**Stephen J McGivern
Building Consultant
Melrose House
Hinderwell
TS13 5ES**

PROPOSED DORMERS, THE COBLE, ROBIN HOODS BAY

PROPOSED CAT SLIDE DORMERS at THE COBLE, ROBIN HOODS BAY
for Mr & Mrs MACK
PLAN, ELEVATION AND SECTION AS PROPOSED
 Scale: 1:50 (plan and section) 1:75 (elevation)

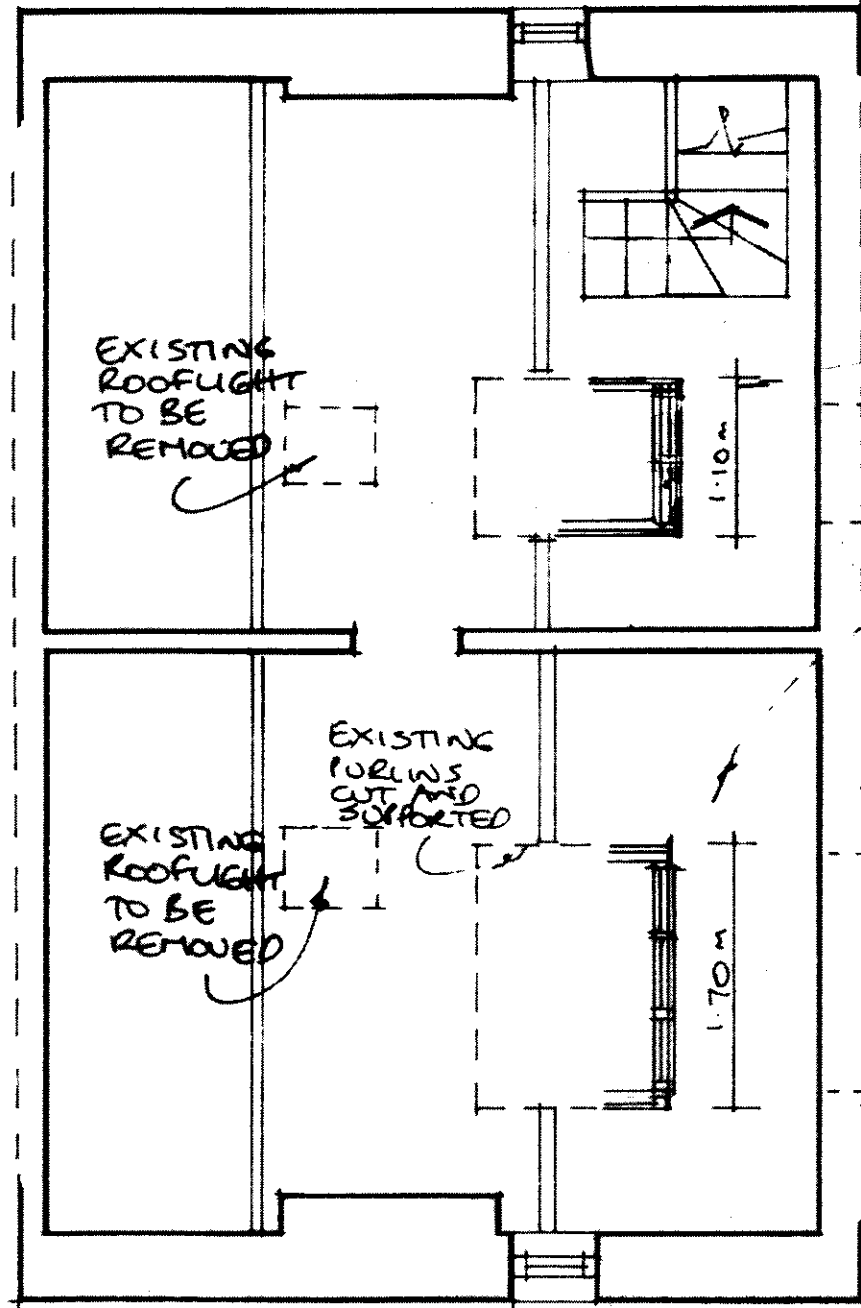
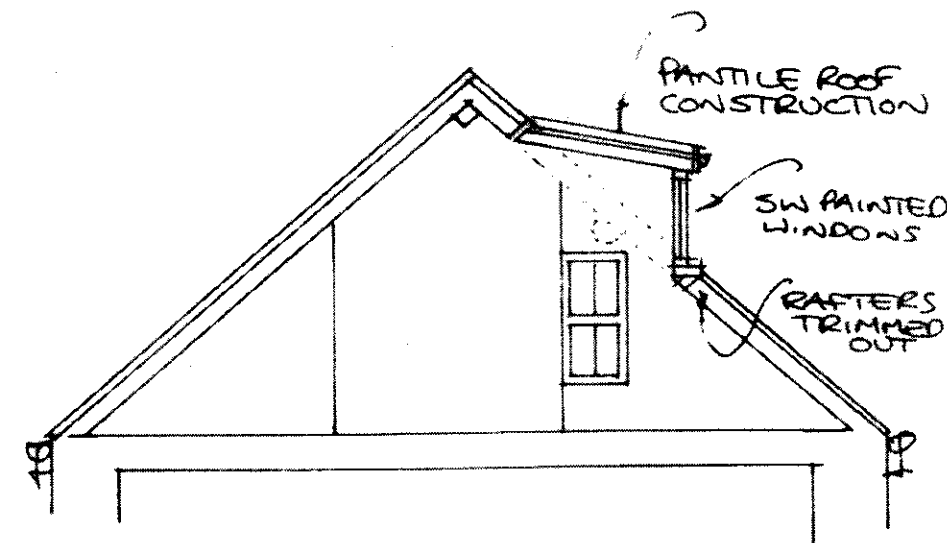
Please find enclosed altered drawings related to the above application. As you will note the request to alter with regard to existing rooflights, glass cheeks and side hung casements have been complied with, however my Client is minded to pursue the proposals as previous with regard to size and positioning.

WINDOW - SIDING CASEMENTS OF TREATED SOFTWOOD AND WHITE GLOSS PAINTED

CHECKS - TIMBER FRAME WITH DOUBLE GLAZED INFILL.

AMENDED
Notes
